Staff Report

Date: December 9, 2020

Re: Alta Depot
Petition PLNPCM2020-00220 – Design Review
Petition PLNPCM2020-00221 – Planned Development

ALTA DEPOT

2 ELEVATION - WEST (S 600 W)

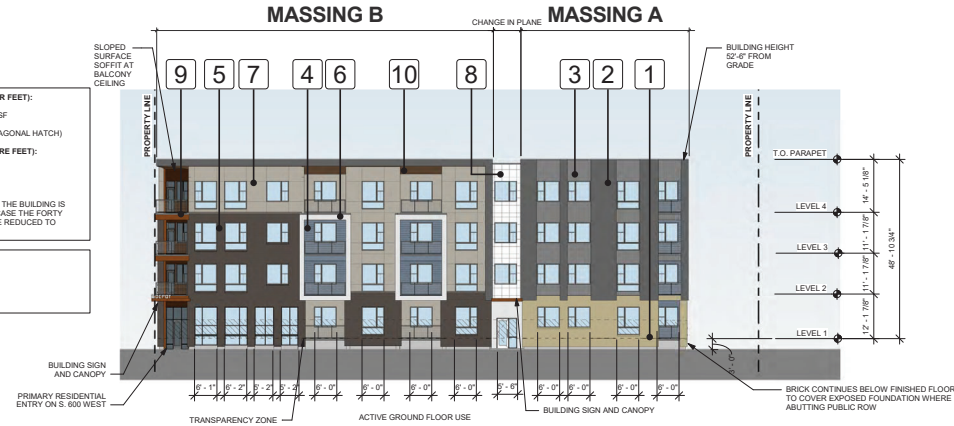
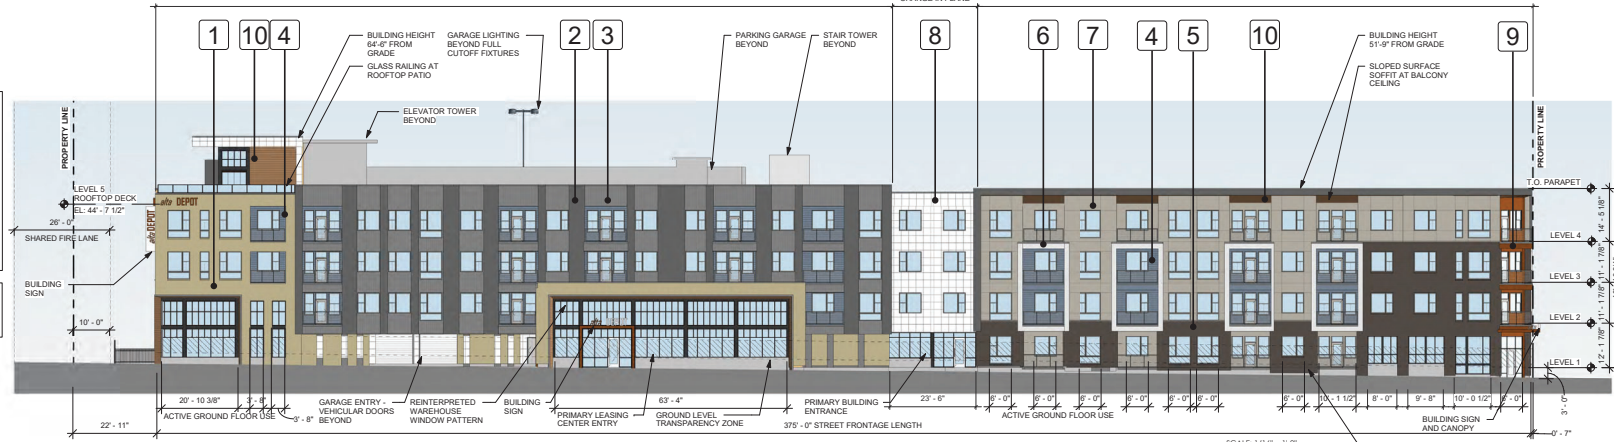
See Sheet A13 of the attached submittal for the calculations of required transparency/glass surface for this zone district.

GROUND FLOOR GLASS PERCENTAGE (LINEAR FEET):
S 600 W STREET CALCULATION:
ZONE BETWEEN 3' & 8' ABOVE GRADE = 721.5 SF
25% TRANSPARENCY REQ'D = 180.4 SF
TRANSPARENCY PROVIDED = 310.5 SF (43% - DIAGONAL HATCH)

GROUND FLOOR GLASS PERCENTAGE (SQUARE FEET):
S 600 W STREET CALCULATION:
STREET FRONTAGE LENGTH = 144' - 11 1/2" LF
25% TRANSPARENCY REQ'D = 36.08 LF
TRANSPARENCY PROVIDED = 76 LF (52%)

21A.31.010.P.3.A.(1)(C) THE GROUND LEVEL OF THE BUILDING IS OCCUPIED BY RESIDENTIAL USES. IN WHICH CASE THE FORTY PERCENT (40%) GLASS REQUIREMENT MAY BE REDUCED TO TWENTY FIVE PERCENT (25%).

ARCHITECTURAL SITE
PLAN / LEVEL 1 PLAN

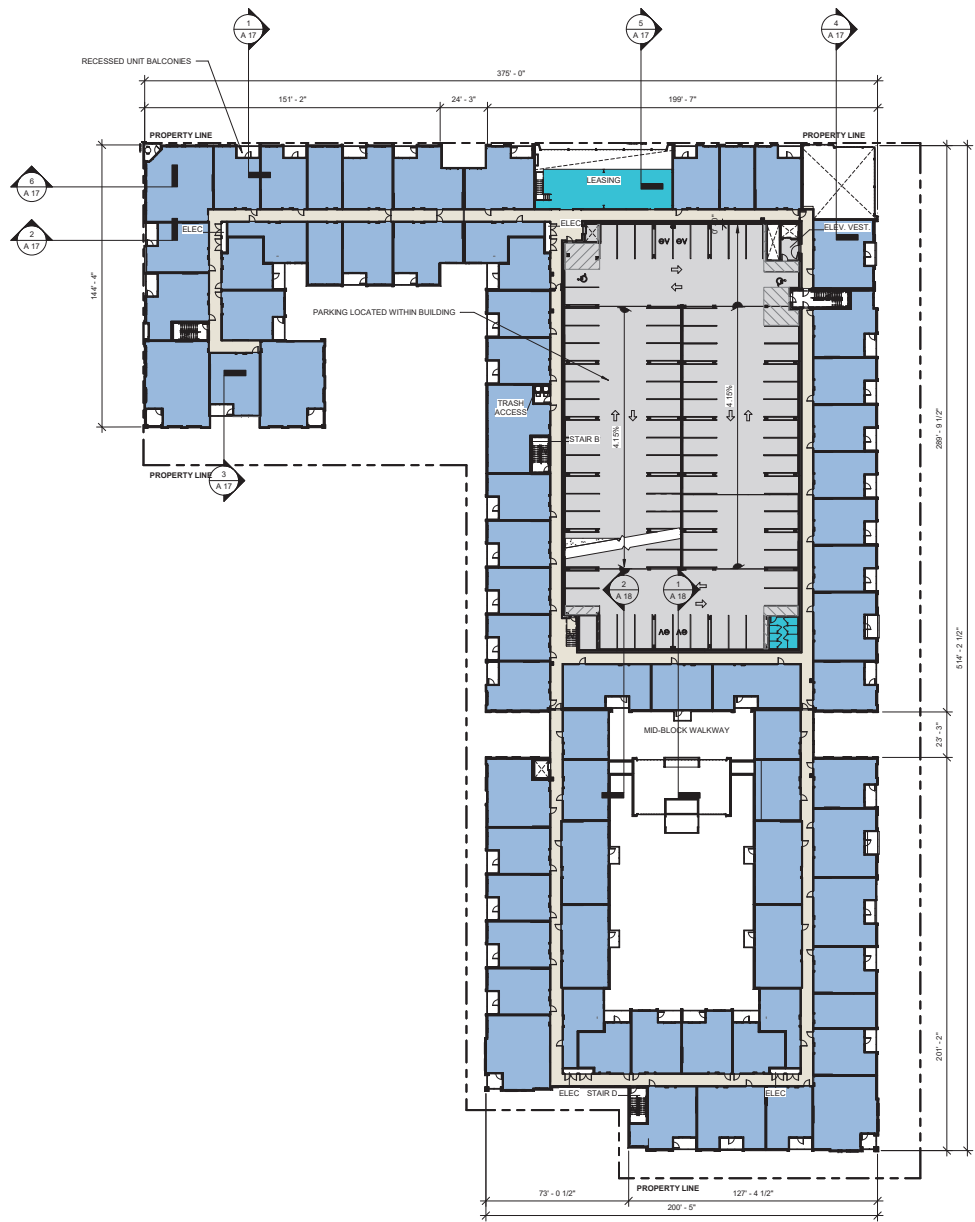
Submittal Response: All loading and services (trash, utilities) are located on the interior of the lot, and are accessed via a private drive aisle off of S 600 West. This private drive also serves as a Fire Department access and accommodates Fire Truck and Loading turnaround space. See Sheet A2 of the submittal package for loading and trash locations.

Submittal Response: Trash facilities for the project are completely enclosed within the building, and not visible from the exterior. See Sheet A2 for location of trash facilities.

RESPONSE: Noted: A permanent recycling collection station will be provided within the building's trash termination room. See Sheet A2 – Site Plan/Level 1 Plan attached for location noted on the ground floor, west side of the building.

A Secured Bike Storage room with at least 20 secured bike parking spaces will be provided within the garage of the building on the ground floor, close to the exterior 100 South. See location noted on Site Plan/Level 1 Floor Plan, Sheet A2.
